CITY OF ALBUQUERQUE

RE: **Tr X-1, Airport Park**
2500 Yale Blvd SE
Grading Plan Stamp Date: 09/17/18
Hydrology File: M16D011D

Based on the submittal received on 9/21/18, the grading plan cannot be approved until the following are corrected and a complete resubmittal is made:

GRADING AND DRAINAGE PLAN

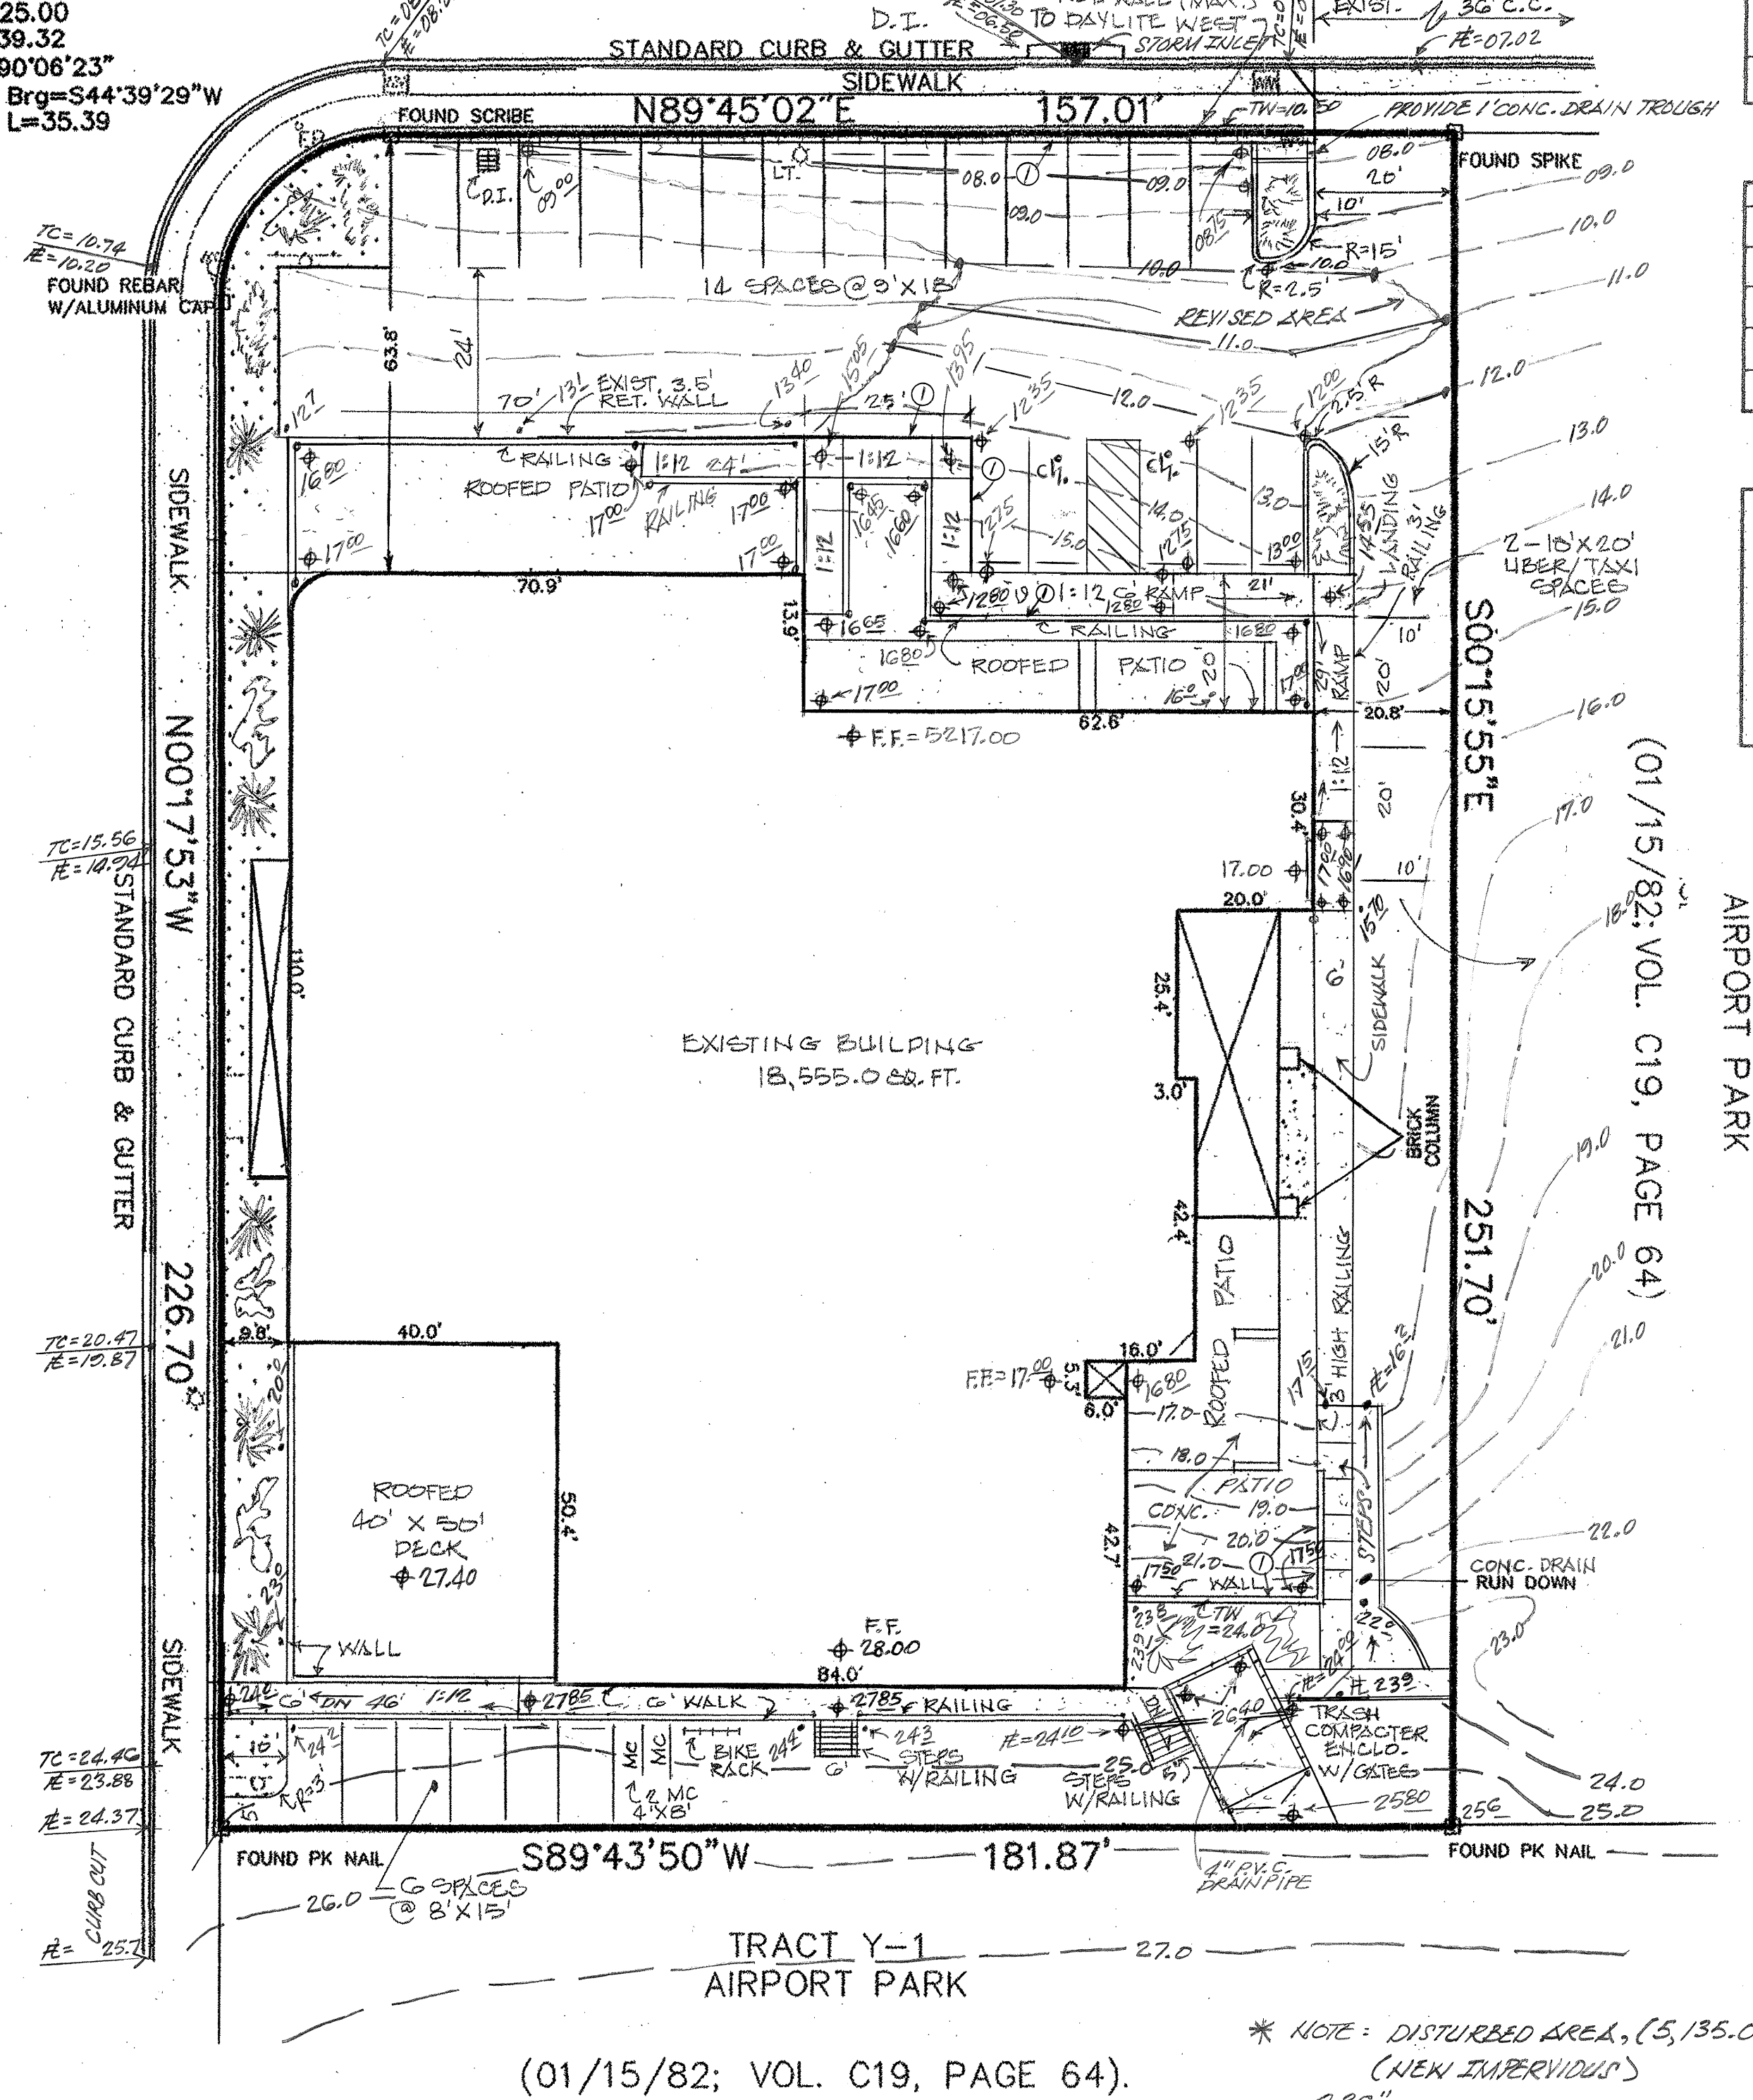
2. Include elevation datum for the benchmark.
3. Only one paper copy (and the electronic copy) is required for Hydrology submittals.
4. Add note on the plan that "No work shall be performed in the public ROW without an approved Work Order or Excavation Permit."

5. Why is the top of the retaining wall along Alamo labeled as 10.50', but the adjacent proposed parking lot grade is only 8.75'?
6. The areas of repaving and new buildings must be clearly defined on the plan and included in first flush calculations and determination of Fee-in-Lieu. This redeveloped impervious area is then used to determine the first flush retention volume at a rate of 0.26" x impervious area.

- a. If requesting Fee-in-Lieu for the first flush volume, please state on the plan so a deposit slip can be generated for the first flush volume at a rate of \$8/CF.

- b. Otherwise provide a suitably located and sized pond to capture this volume from impervious areas.
7. For Information. The new Drainage Ordinance was passed by City Council on 9/17/18 and is pending mayor signature and enactment. This may affect the timing and approval of this project. If seeking approval under the current ordinance, Fee-in-Lieu may be accepted. If seeking approval under the new ordinance, Fee-in Lieu cannot be accepted and on-site

ponding (including underground ponding) is required for the first flush volume to the greatest extent feasible. The grading plan will need to clearly justify why the storm water quality volume can or cannot be retained (economic reasons are not considered in the feasibility).
